Recommended remedial Works to Large Detached Barn, as Structural Engineer's Comments.

Client	The Woodfold Estate Partnership
Job Title	Proposed Development at Lower Reaps Farm, Whinney Lane, Mellor

Drawing Title	Proposed Barn Floor Plans and Elevations
Scale	1:100 @ A1
Date	April 2022
Drawn	RS

PROPOSED SOUTH FACING ELEVATION SCALE 1:100

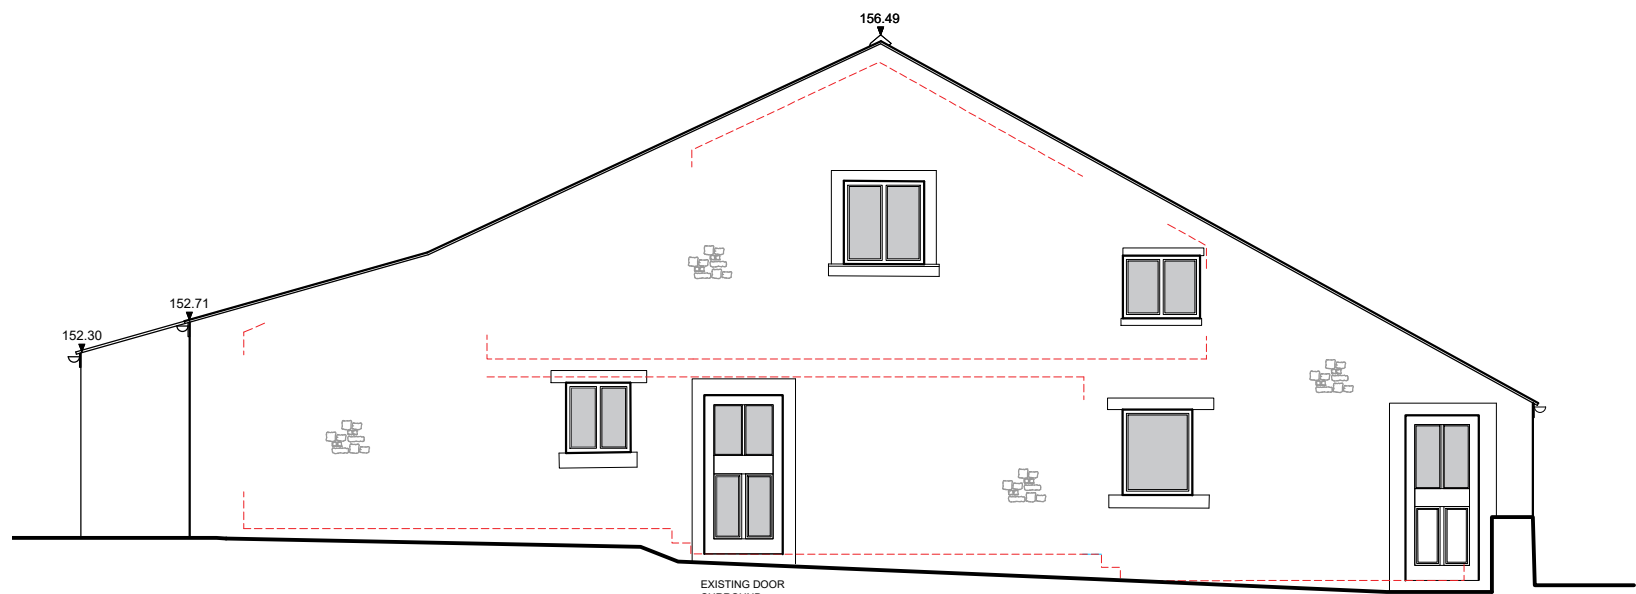
- Section of existing collapsed external wall on South Facing Elevation, will require reinstatement from where it is sound, up to eaves level.
- Minor cracking to the inner face of the Northern Barn wall, at the junction with West Gable wall, to be repaired with steel straps across the cracks.
- The external walls to all four elevations, require full and comprehensive re-pointing, with lime mortar.
- The existing timber roof trusses and structure will require closer examination with a proposed repair / replacement method statement required.
